**SH/08/124/R7 & 34 Otterpool Quarry, Ashford Road, Sellindge, Ashford**

A report by Head of Planning Applications Group to Planning Applications Committee on 12 March 2014.

SH/08/124/R7 & 34 - Details pursuant to conditions (7) – weighbridge and office facilities and (34) – Landscaping at Otterpool Quarry, Ashford Road, Sellindge, Nr Ashford TN25 6DD (MR. 112 365).

Photograph (and annotations) provided by the SDRA

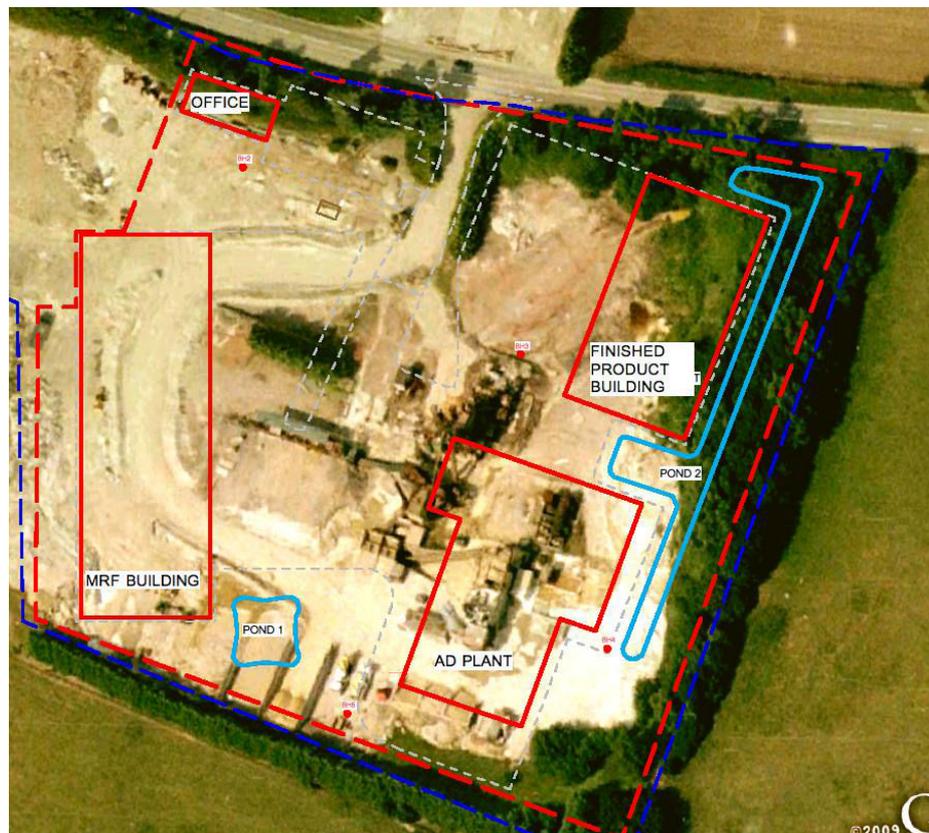
- The submission fails to detail the existing trees shrubs and hedges to be retained, and fails to identify trees shrubs and hedges proposed to be removed. The absence of a level survey or tree survey across the relevant areas along the boundary areas perimeter signifies this beyond any doubt.

- Should this condition be discharged under the present circumstances the consequence would be the exposure of the proposed development to clear view from all compass directions.

- Just to clarify the area of concern this is an aerial photograph with the main components of the development overlaid. The impact on the boundary planting is all too clear from this. When you add into this the issue of levels and ground topography the significance is even greater.

26. The applicants have clarified that although a detailed tree survey has not been carried out, all the existing planting that can be retained would be retained and would be reinforced with new native screen planting.

27. Trees to be removed along the northern boundary are Leylandii Conifers that are within the visibility splay and in the proposed car park, however they are not native and are considered inappropriate species in this setting. The maximum width of the screen to the north is 14m and the minimum width is 7m.

28. The Applicant's Landscape Architect further clarifies that much of the existing planting along the eastern boundary is also going to be retained which extends to over 7m in width. An additional 3m of new planting would be planted along the edge of the attenuation pond where existing planting would be removed when the pond is formed. The planting extends to over 28m width in the south eastern corner.
